Products: MF-9101 series, MF-914, CPA-9000 series and LMH5 series

Please be informed that the material for the Control-bar shafts on the models mentioned above will be changed due to the supplier's circumstances.

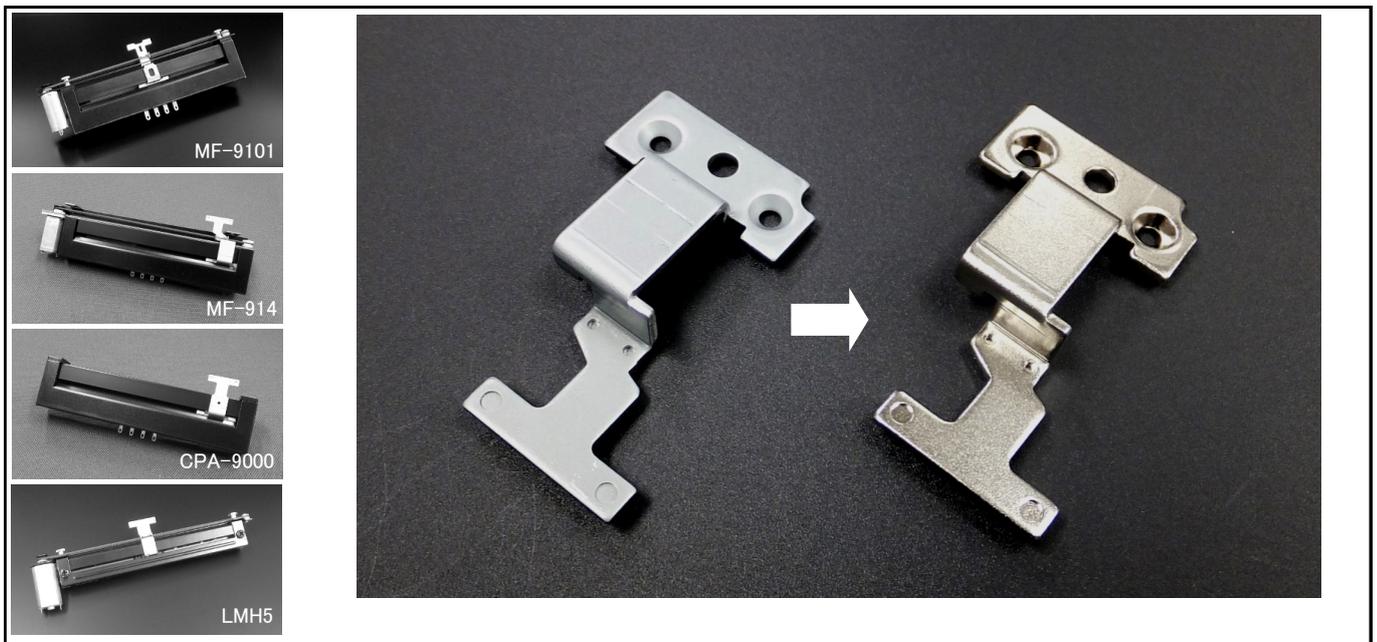
- * The material will be changed from Electro galvanized zinc plated steel to SPCC with nickel plating.
- * There is no change in the electrical or the mechanical specification.
- * No problem with the same usage as previous.
